TECHNICAL MEMORANDUM

Subject: Potential hydrologic impacts to surface- and ground-water resources within Rio Arriba County caused by the drilling of oil wells by Approach Operating, LLC.

Subject: Potential hydrologic impacts to surface- and ground-water resources within Rio Arriba County caused by the drilling of oil wells by Approach Operating, LLC.

Figure 1. Topographic map showing the location of protested NMOCD well permits (yellow circles) and permit applications (triangles) in the Rio de Tierra Amarilla Watershed, Rio Arriba County.

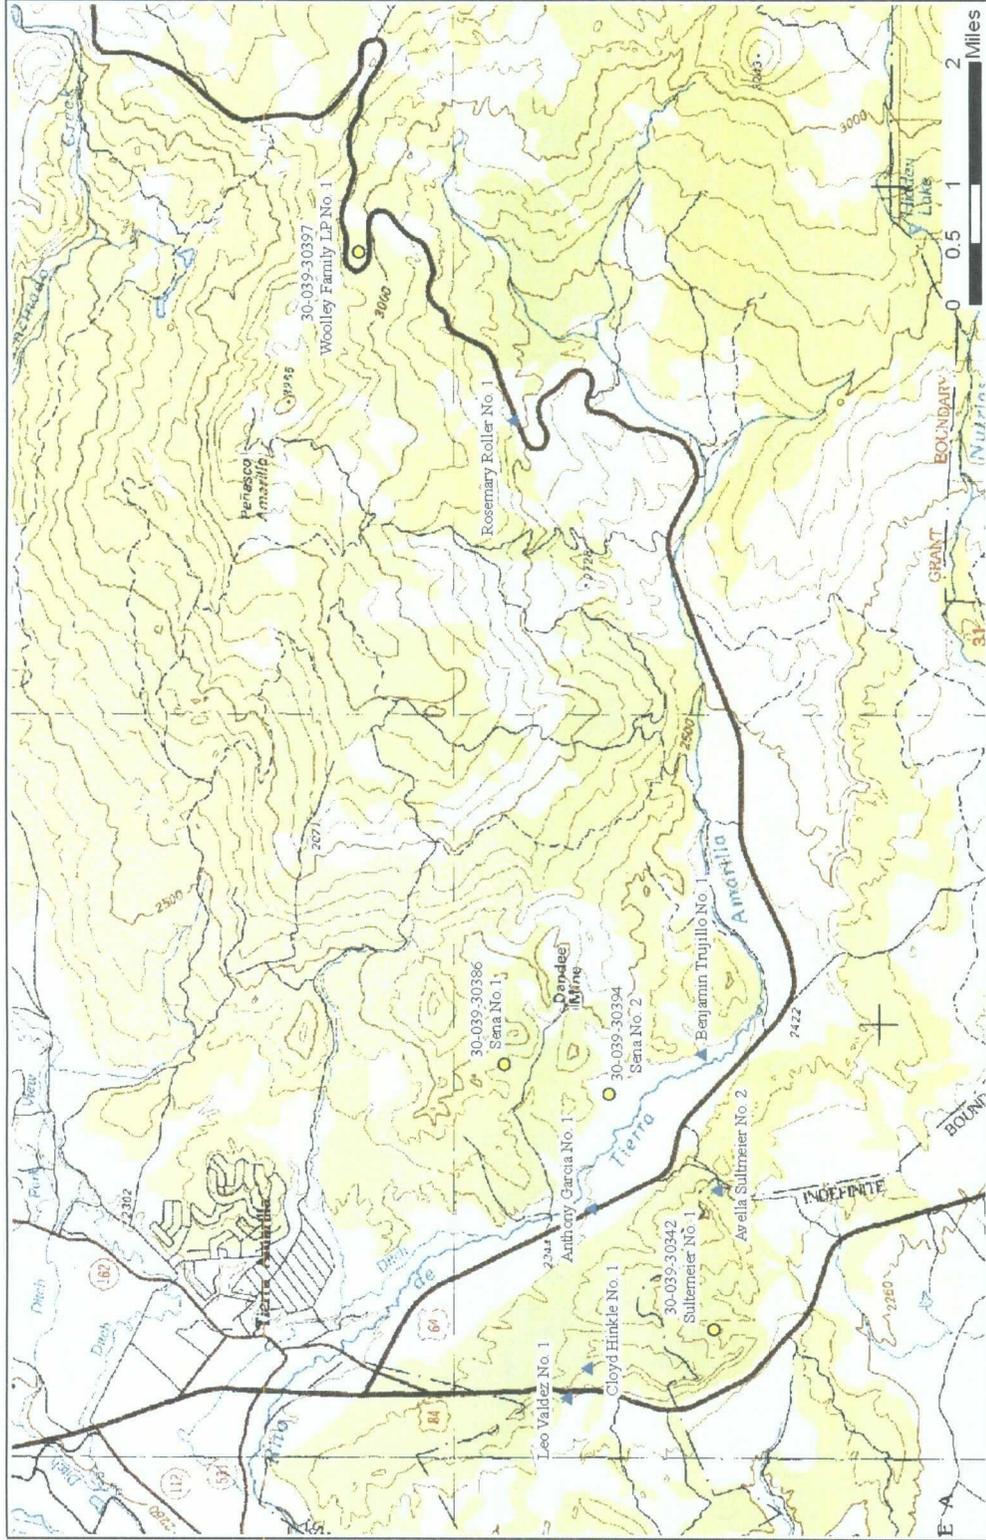
The permitted wells are located in the Rio de Tierra Amarilla watershed, upstream of Tierra Amarilla, New Mexico (Fig. 1). The Rio de Tierra Amarilla is one of the major perennial tributaries to the Rio Chama. The New Mexico Water Quality Control Commission (NMWQCC, 20 NMAC 6.1 2116) has the following Designated Uses to the Rio de Tierra Amarilla:

Not shown on Figure 1, is a detailed network of irrigation ditches and irrigated agricultural lands that rely on the Rio de Tierra Amarilla and associated tributaries.

Figure 2. Aerial photograph showing Woolley Family LP No. 1 well permit location.

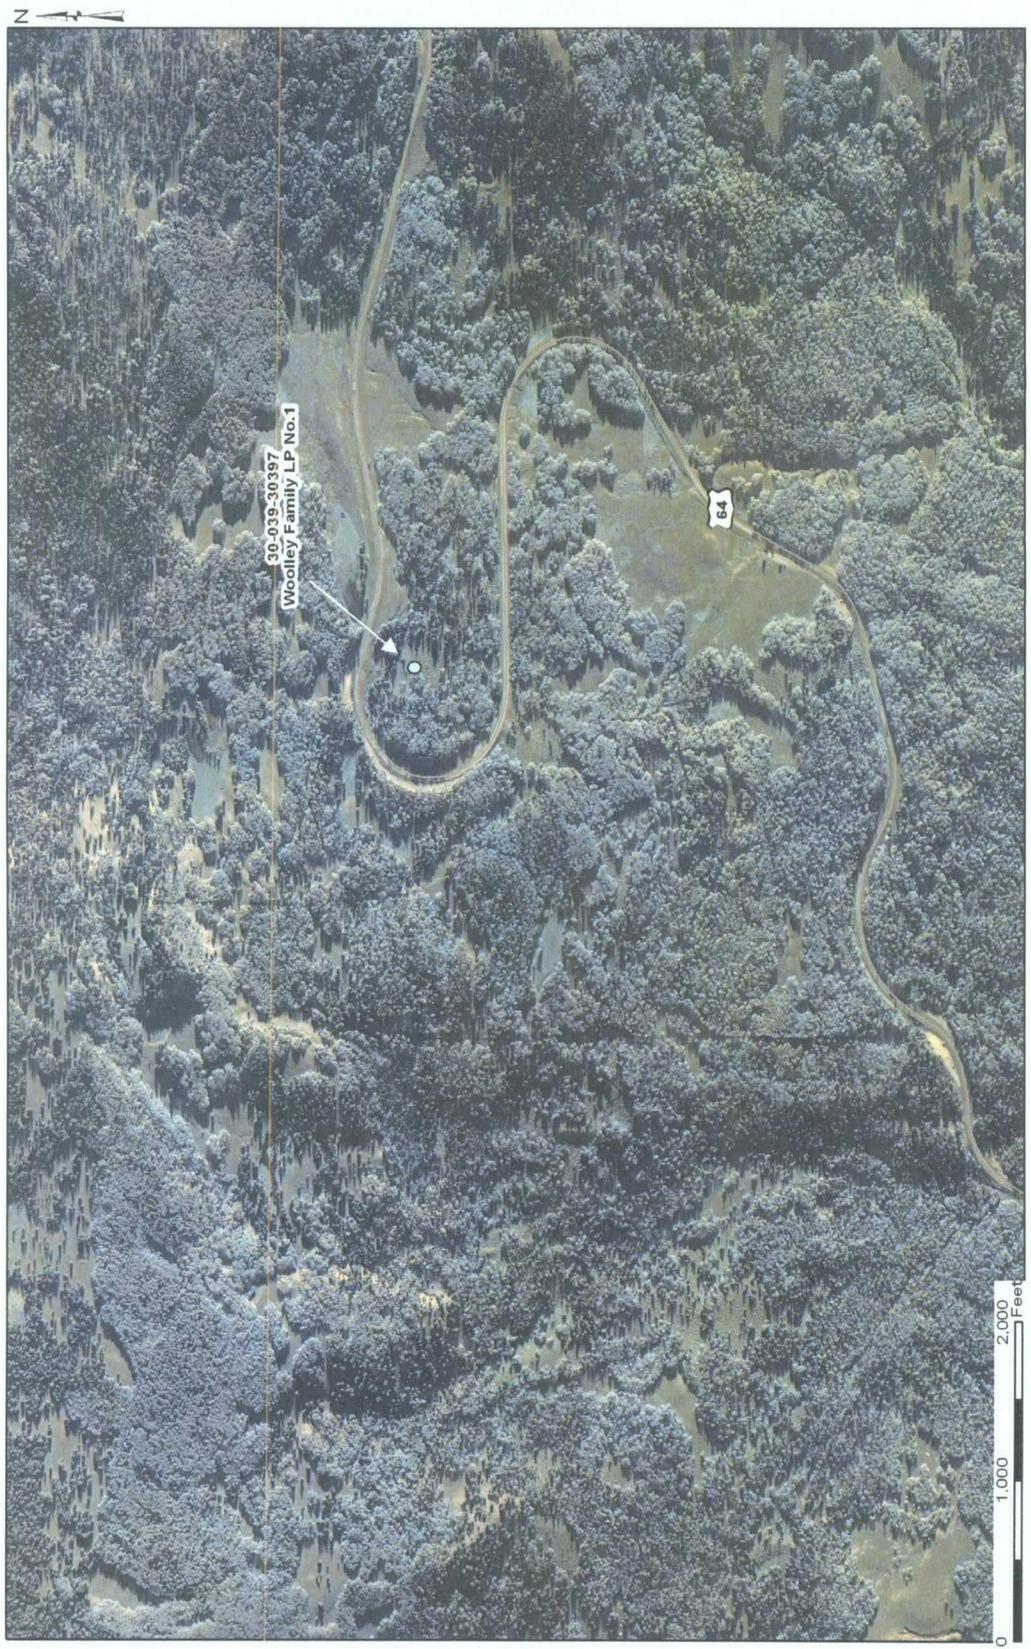
The information listed on the NMOCD well permits (Table 3) appears to be estimated and not site specific. Aerial photographs showing well locations are presented as Figures 2 and 3. A close examination of Figure 2 shows several surface-water ponds within 500 ft of Woolley Family LP Well No. 1. These surface-water ponds are the head waters for the Rio de Tierra Amarilla, and important sources of water for wildlife and livestock. The Sultemeier Well No. 1 and Sena No. 2 (Fig. 3) are located in or adjacent to natural drainages that likely convey surface water during spring runoff and summer storms. The Sena No. 1 location appears to be on a ridge, and approximately 500 ft on either side of the ridge are surface-water drainages with ponds and irrigation ditches. The Sena No. 1 permit lists the Nutrias Ditch No. 1 as greater than 200 ft from the proposed well location.

SITING EVALUATION

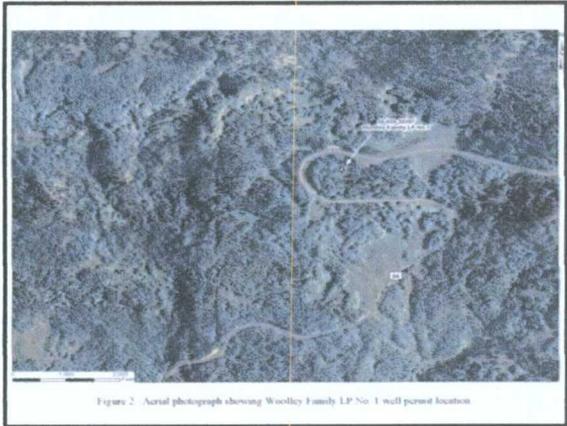
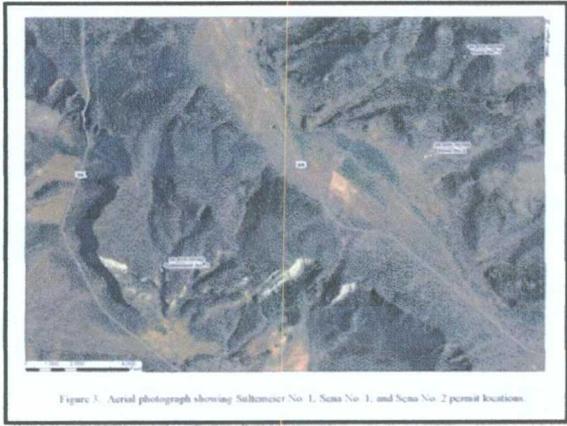
- Well locations are in bottom of water course areas or in wetlands.
- No projections for timing impact on watershed and foot print.
- Depth to water has not been determined at these sites, and is likely less than 25 ft.
